Condition of Approval:
Construction of any impervious surfaces (roadways, sidewalks, etc.) within Sterling Ranch East Filing 6 shall not begin until Pond FSD-16 and accompanying stormwater infrastructure required to direct flows from Sterling Ranch East Filing 6 to Pond FSD-16 are substantially completed. These areas require treatment from Pond FSD-16.

STERLING RANCH EAST FILING NO. 6 CONSTRUCTION PLANS STREET SECTIONS / EROSION CONTROL NOTES			
DESIGNED BY	MAW	SCALE	DATE
DRAWN BY	ESO	(H) 1" = N/A	SHEET 2 OF 49
CHECKED BY		(V) 1" = N/A	JOB NO. 1183.25

STERLING RANCH EAST FILING NO. 6
CONSTRUCTION PLANS
GRADING AND EROSION CONTROL PLAN

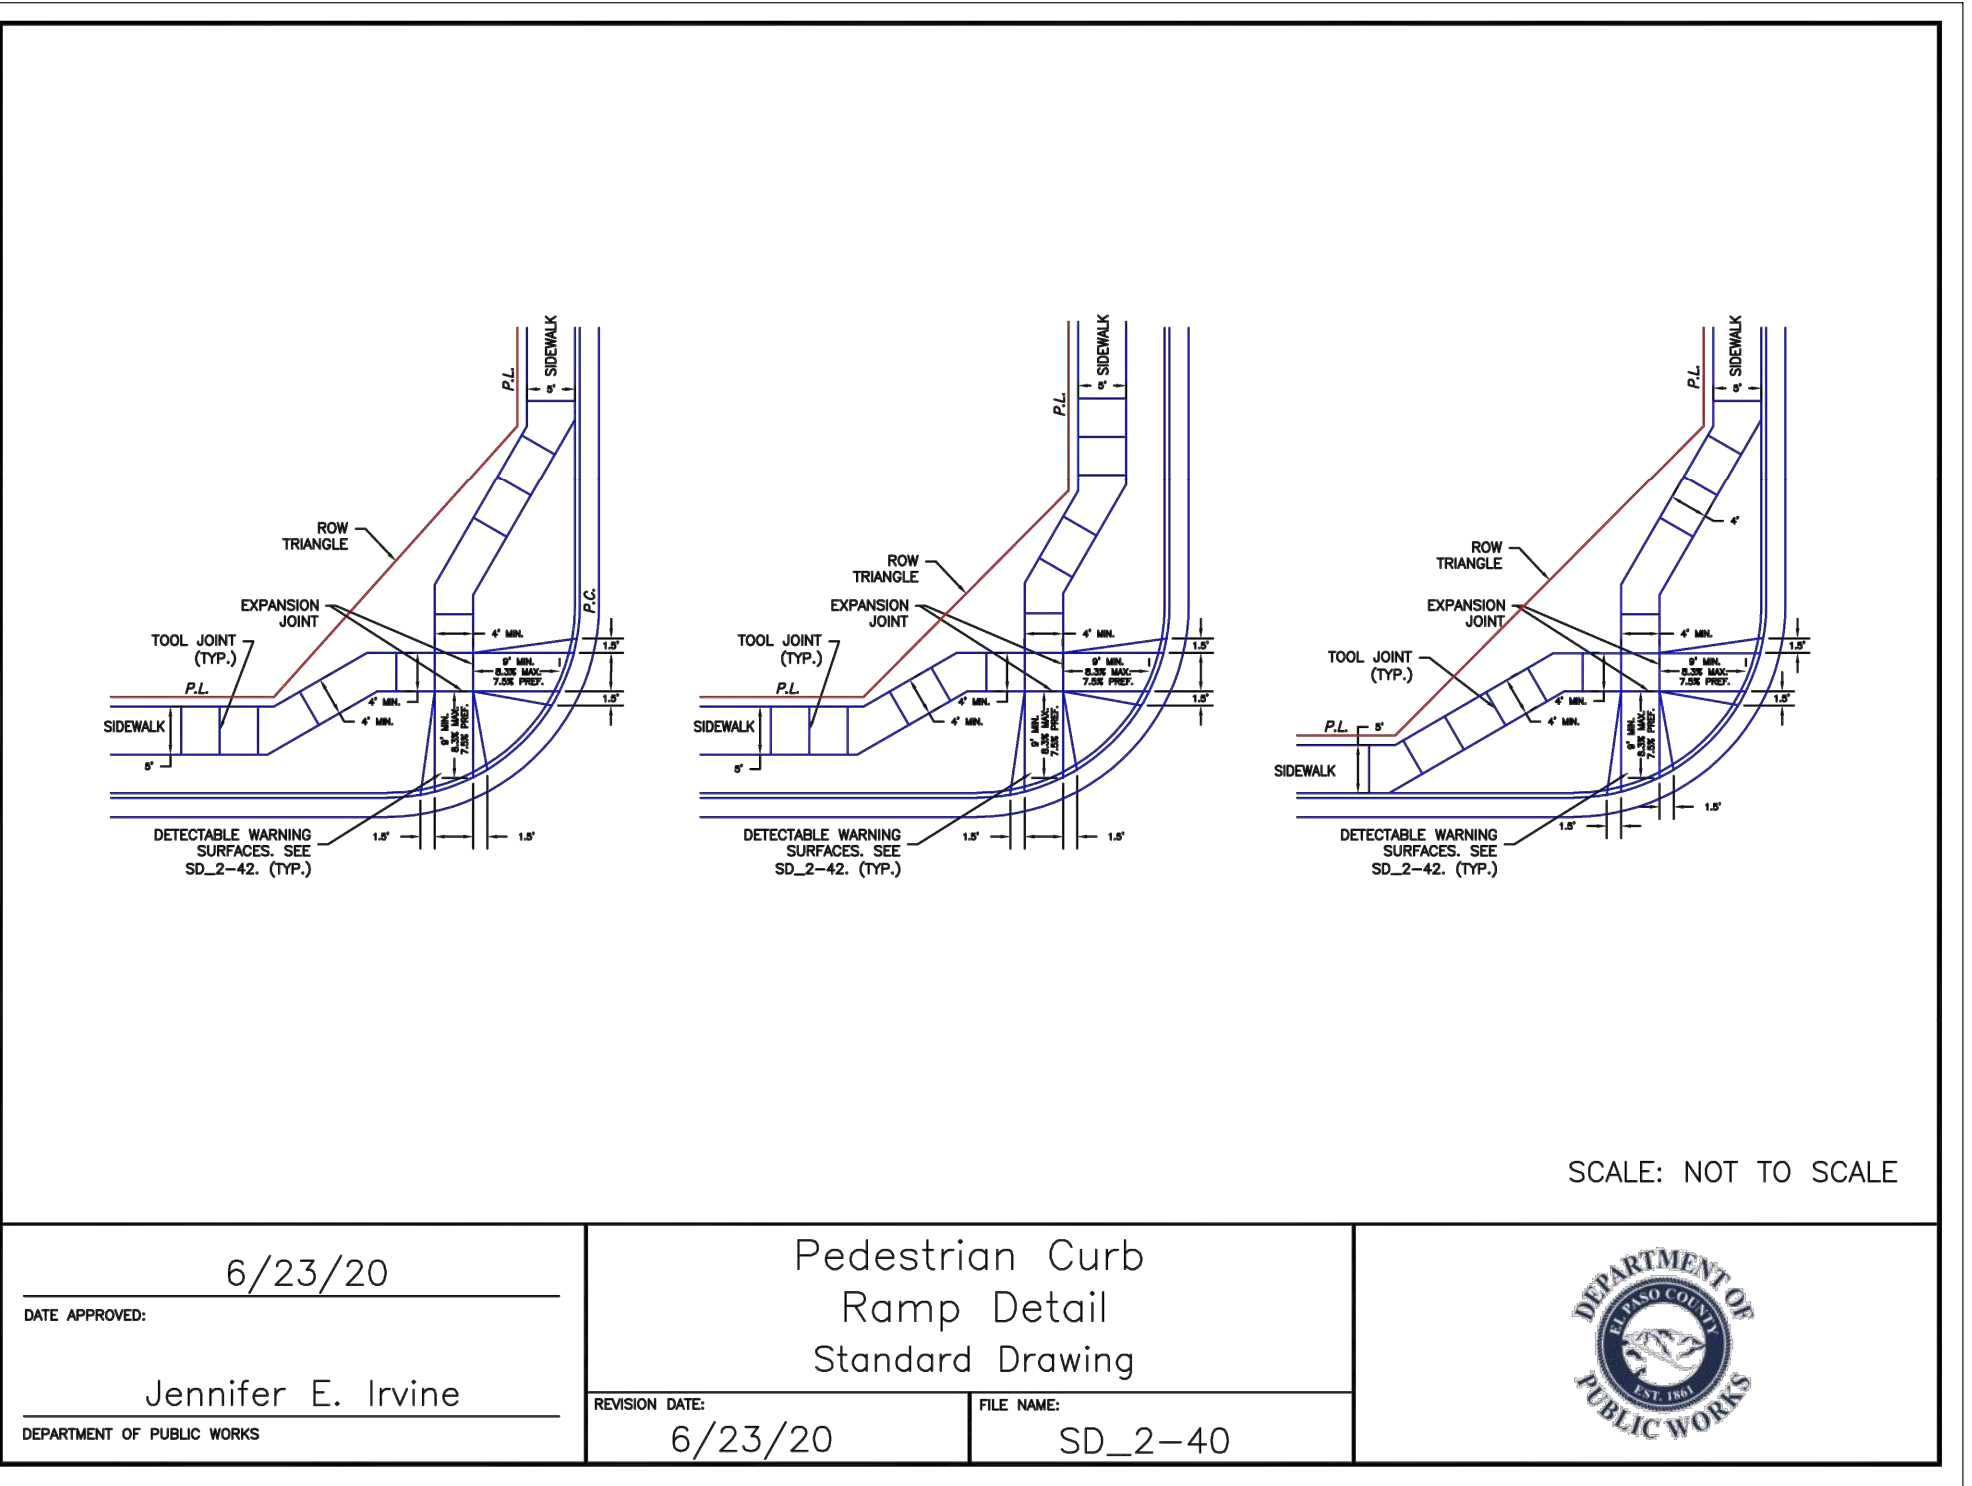
Use current standard notes for EPC GEC plans (attached).

Include details for c&g, median, ped ramps (SD 2-41, SD 2-42 & SD 2-50)

Remove this note since this is CD's and the FDR has been provided.

REVISED NOTES

ADDED SEE SHEET 27

REMOVED NOTE 2

STRELING RANCH EAST FILING NO. 6
CONSTRUCTION PLANS
PUBLIC STORM SEWER PLAN

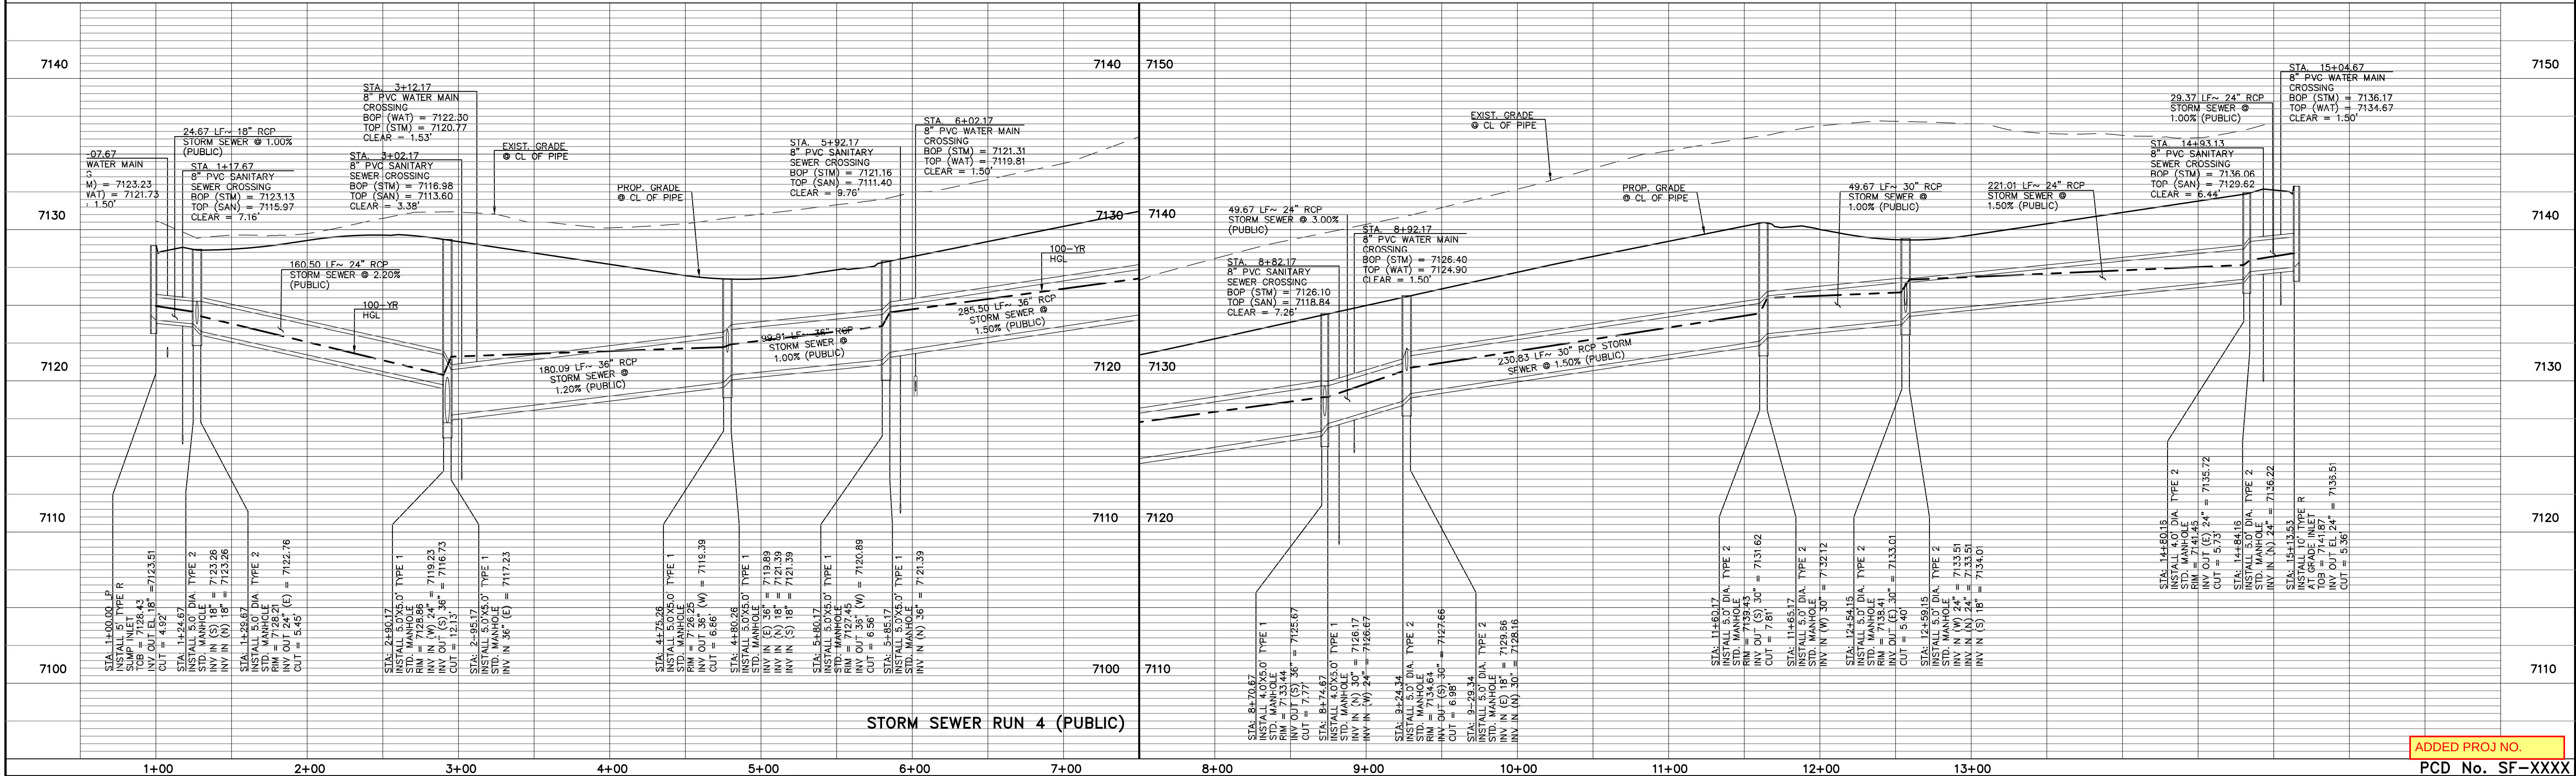
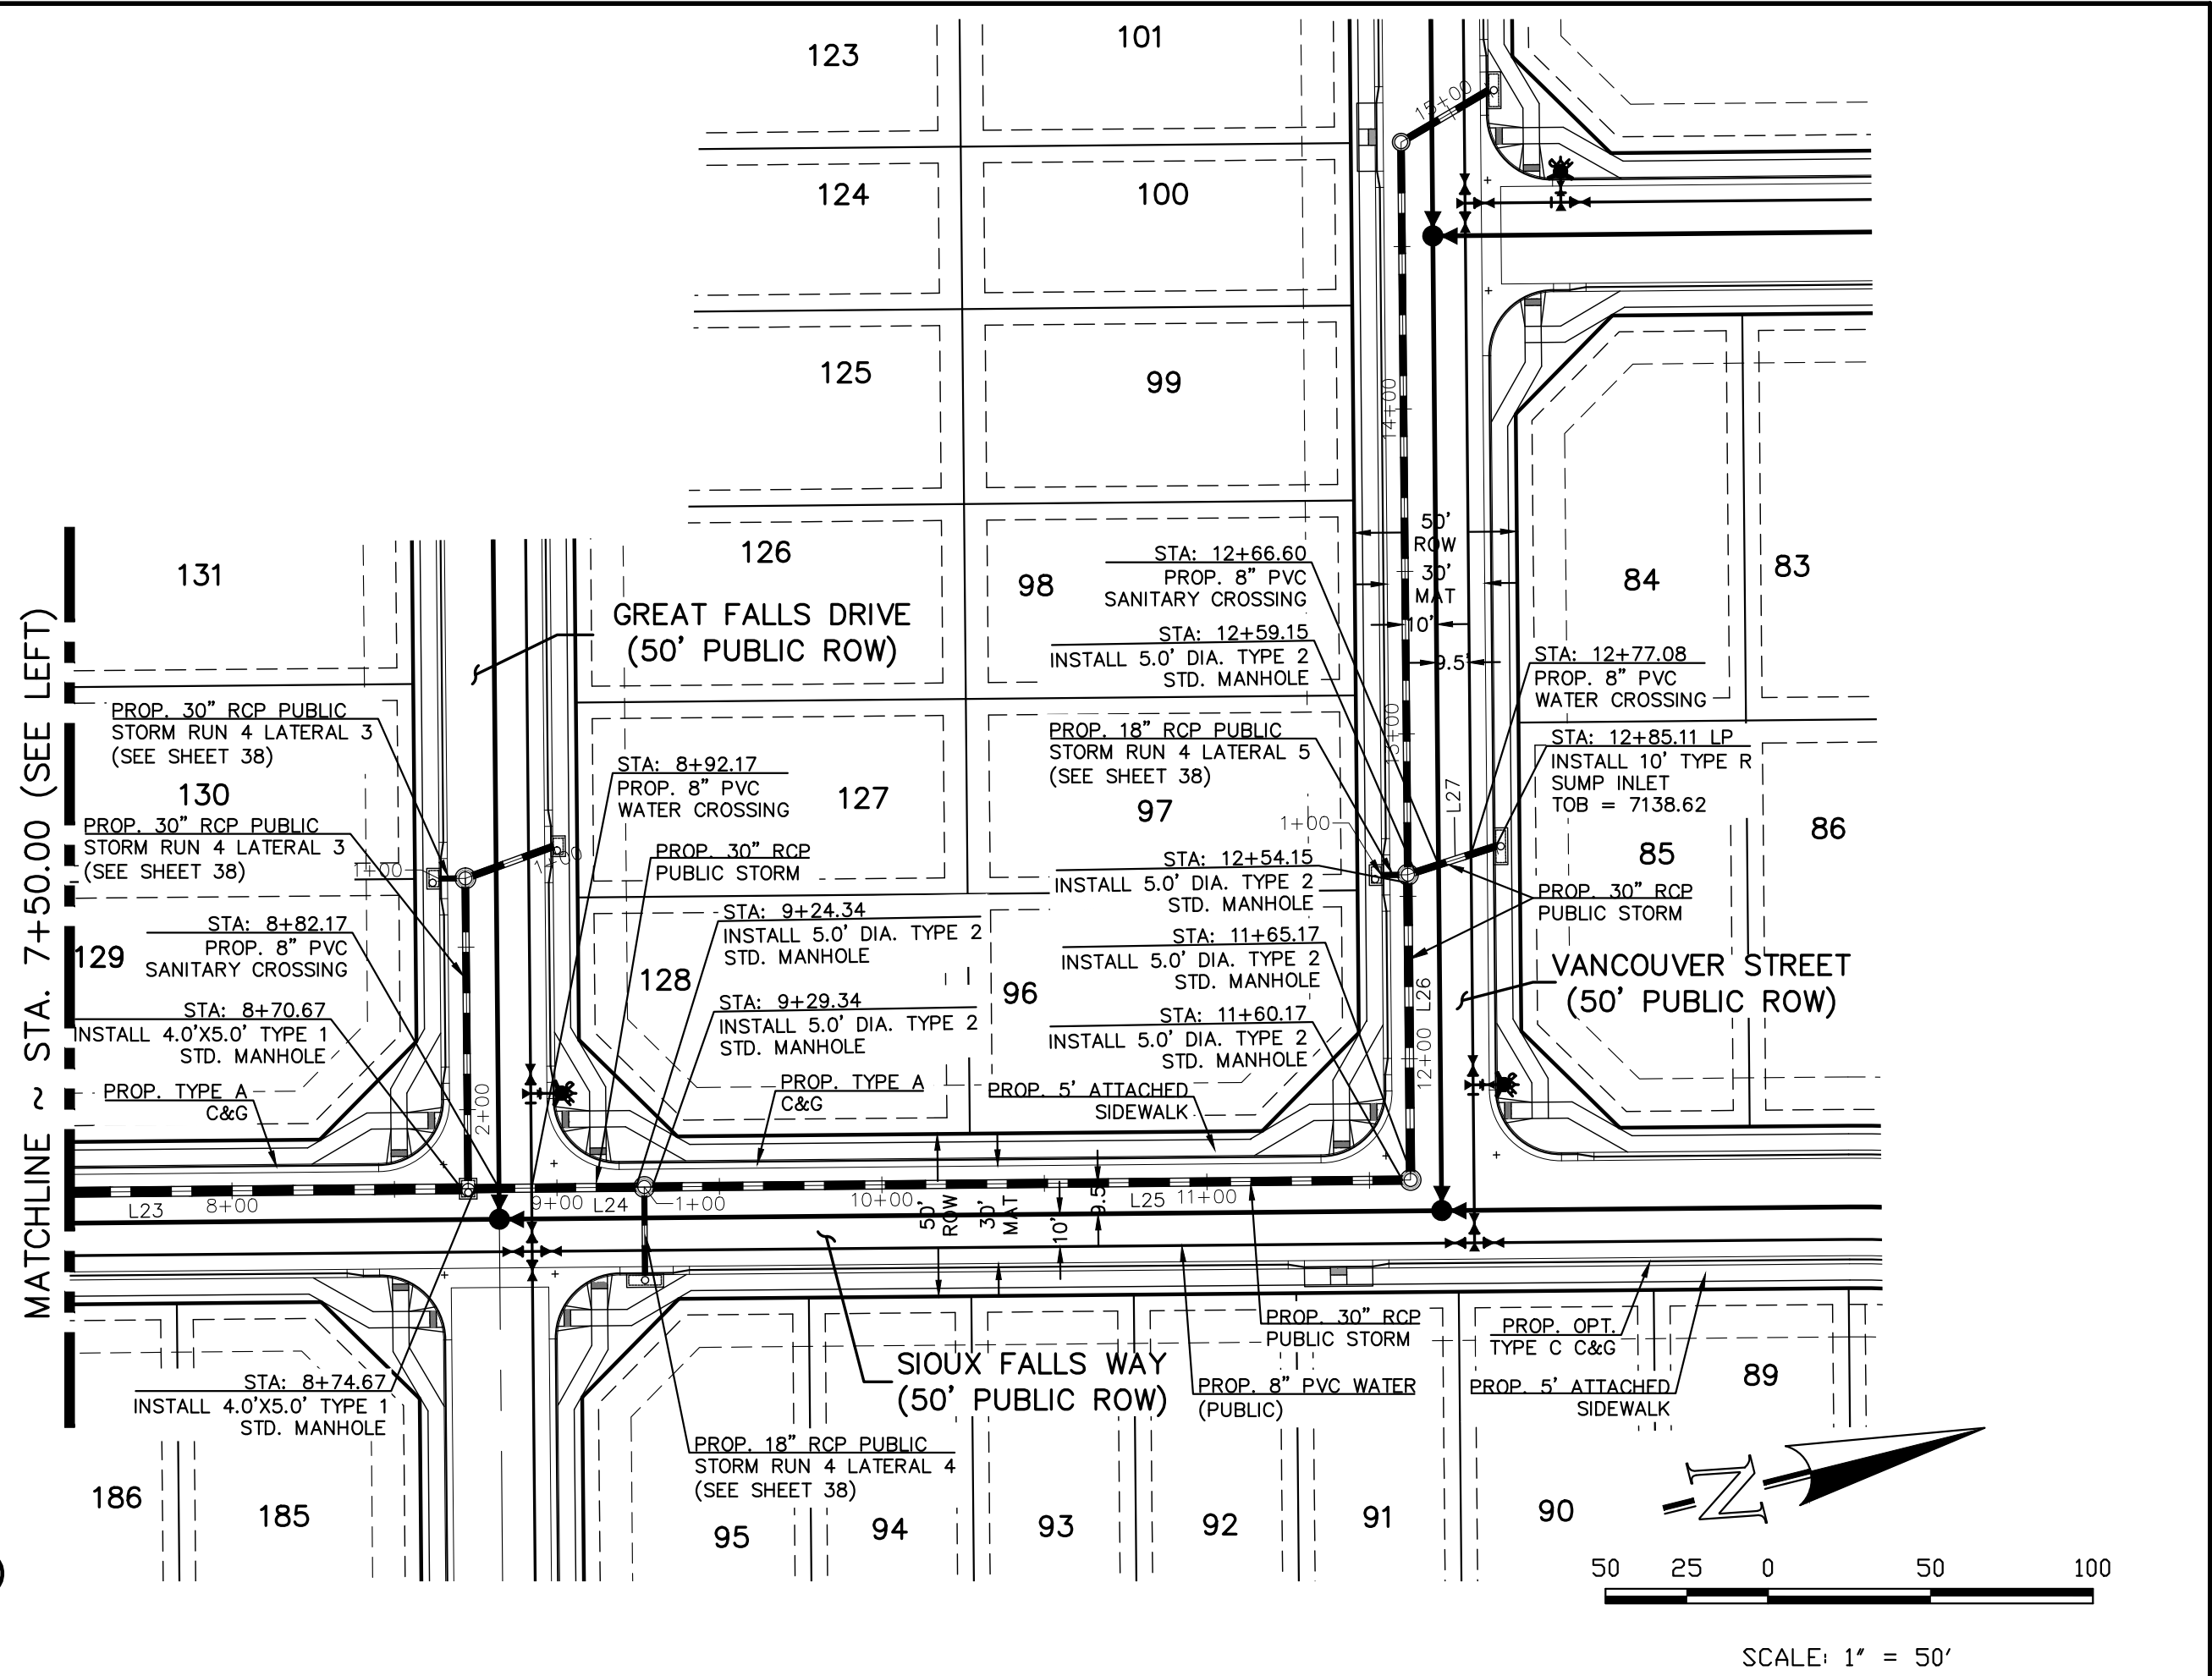
Include this note on all storm sheets

THIS NOTE IS SHOWN ON ALL SHEETS
(SEE BOTTOM LEFT)
